9.5 Other Auxiliary Systems

The information in this section of the reference ABWR DCD, including all subsections, tables, and figures, is incorporated by reference with the following departures and supplements.

STP DEP 1.1-2 (Table 9.5-5, Figure 9.5-2)	STD DEP 9.5-3
STD DEP 8.3-1	STD DEP 9.5-4
STD DEP 9.4-2 (Table 9.5-5)	STP DEP 9.5-6 (Figure 9.5-6)
STD DEP 9.5-1	STP DEP 9.5-7 (Table 9.5-5)
STD DEP 9.5-2 (Figure 9.5-3, replaced entire figure)	STD DEP Admin

Figure 9.5-3 Lower Drywell Flooder System Arrangement/Configuration

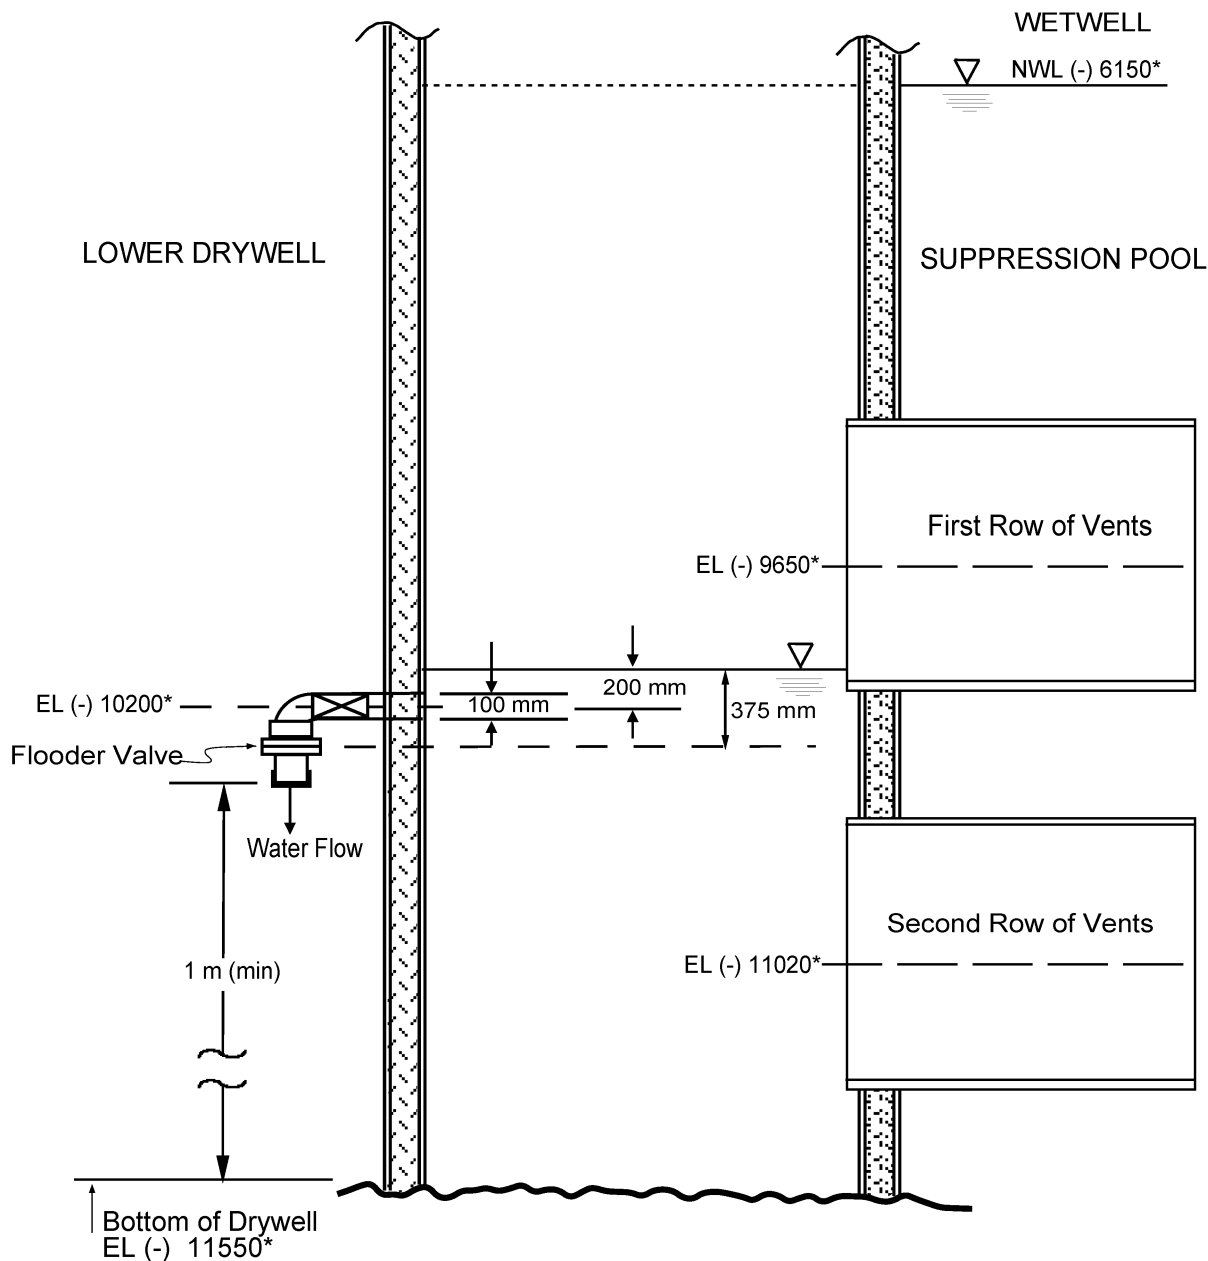
STD DEP 9.5-2

The LDF, shown schematically in Figure 9.5-3, provides a flow path for suppression pool water into the lower drywell area during severe accident scenario that leads to core meltdown, vessel failure, and deposition of molten corium on the lower drywell floor. Molten corium is a molten mixture of fuel, reactor internals, the vessel bottom head and control rod drive components. The flow path is opened when the lower drywell airspace temperature reaches 260°C ± 10°C.

The LDF consists of ten pipes that run from the vertical pedestal vents into the lower drywell. Each pipe ~~contains~~ has an isolation valve and a fusible plug valve connected to the end of the pipe that extends into the lower drywell ~~by a flange~~. The fusible plug valves open when the drywell air space ~~(and subsequently the fusible plug)~~ temperature reaches 260°C ± 10°C. When the fusible plug valves open, a minimum of 10.5 L/s of suppression pool water will be supplied through each floodor pipe (105 L/s total) to the lower drywell to quench the corium, flood the lower drywell and remove corium decay heat, which is estimated at 1% of rated thermal power. The flow rate is based on a minimum hydrostatic head of 200 mm above the floodor pipe inlet centerline and takes the frictional losses through the floodor pipe and fusible plug valve into account.

~~The fusible plug valves are made from flanges welded to the end of the vent inside the lower drywell area. The inner diameter of the pipe is slightly enlarged to accommodate a stainless steel separation disk, an insulating disk and fusible metal. The stainless steel disk prevents suppression pool water from corroding the plug material. The insulating disk thermally insulates the fusible metal from the wetwell water to assure that the fusible metal is not cooled by wetwell water and prevented from melting during the severe accident high lower drywell temperature conditions. Teflon was selected for the insulating disk because it has a softening temperature of 400°C and a maximum continuous operating temperature of 288°C, both of which are above the plug melting temperature. Furthermore, teflon has high chemical resistance and will not adhere to the stainless steel plug or the fusible plug. The end of the fusible plug valve is covered with a plastic cover that has a low melting point. The purpose of the cover is to avoid corrosion of the fusible metal material and to assure that any toxic components from the fusible metal material that might be released do not escape into the lower drywell area during normal plant operation.~~ The fusible plug valves open fully, and stay open when the air surrounding the fusible plug valves reaches 260°C ± 10°C. Opening of the valves is triggered by a temperature sensitive fusible plug (or fusible link) that melts

when the surrounding air in the lower drywell reaches the opening temperature of 260°C nominal. The temperature sensitive fusible material is isolated from the thermal effects of the suppression pool water inside the fusible plugs as required, to assure consistent operation when the 260°C nominal opening temperature is reached. The fusible plug valves are not pressure relief valves. The pressure retaining portions of the fusible plug valves that contact the suppression pool water are made from stainless steel materials. The seals and gaskets used are compatible with suppression pool water at the design pressure and temperature listed in Subsection 9.5.12.3.1. The fusible plug valves have zero leakage under all operating and accident conditions, until the surrounding air temperature reaches 260°C ±10°C. The temperature sensitive fusible material is protected or isolated, as required, from the following: moisture and humidity in the lower drywell, contact with personnel or equipment in the lower drywell, or release of any toxic components to the lower drywell (except during heat-up to 260°C).
